**Transportation
Security
Administration**

MEMORANDUM FOR: Robin Kane
Assistant Administrator
Operational Process & Technology/CTO 10/7/10

SUBJECT: Implementation of Johns Hopkins University Applied Physics
Laboratory Recommendations for Rapiscan Secure 1000 Single Pose
Advanced Imaging Technology

Figure 1. Dose to General Public Above Units

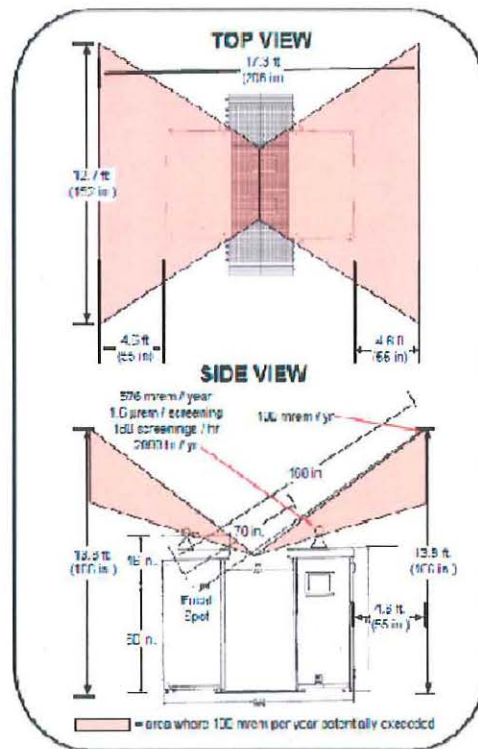
Issue: APL identified an area above the units where the 100 mrem (1 mSv) per year dose limit for bystanders, operators, and other employees could potentially be exceeded only if an individual were to be present in the area 100% of the time for 2,000 hours (a typical work year) and 180 screenings per hour were performed. APL noted that this is a conservative calculation because it is based on the maximum measured dose of 1.6 μ rem (.016 μ Sv) per screening at that location. This area begins approximately 9 feet above the floor and extends

vertically to a height of 14 feet and horizontally 4.6 feet behind each unit, as demonstrated in the figure below.

APL recommended conducting a survey of each installation site to ensure that the dose to any member of the general public is maintained below the 100 mrem (1 mSv) per year and to consider the installation of a beam stop for the area above the units.

Resolution: TSA's routine site acceptance test (SAT) for each installation includes a radiation safety survey. These surveys verify that the unit operates within specifications and are installed correctly and, therefore, the dose to any member of the general public, system operators, or other employees will always be less than 100 mrem (1 mSv) per year. In typical airport configurations, this area is normally unoccupied space between the unit and the ceiling. Additionally, any wall or floor between the individual and the Secure 1000 unit would provide adequate shielding to keep the radiation dose well below 100 mrem (1 mSv) per year.

During the design phase to date for installation of Rapiscan units, TSA has not encountered airports with an occupied space within the 9 to 14 feet zone. However, in the event that there is a balcony or similar structure without any walls or floors, TSA would comply with APL's recommendation to include a beam stop in the design. For sites where a beam stop would be required, TSA is working with Rapiscan to finalize a solution that can be installed on units on an as-needed basis to be determined by the site survey. Rapiscan has provided two beam stop design options for TSA's review as an additional precautionary measure.
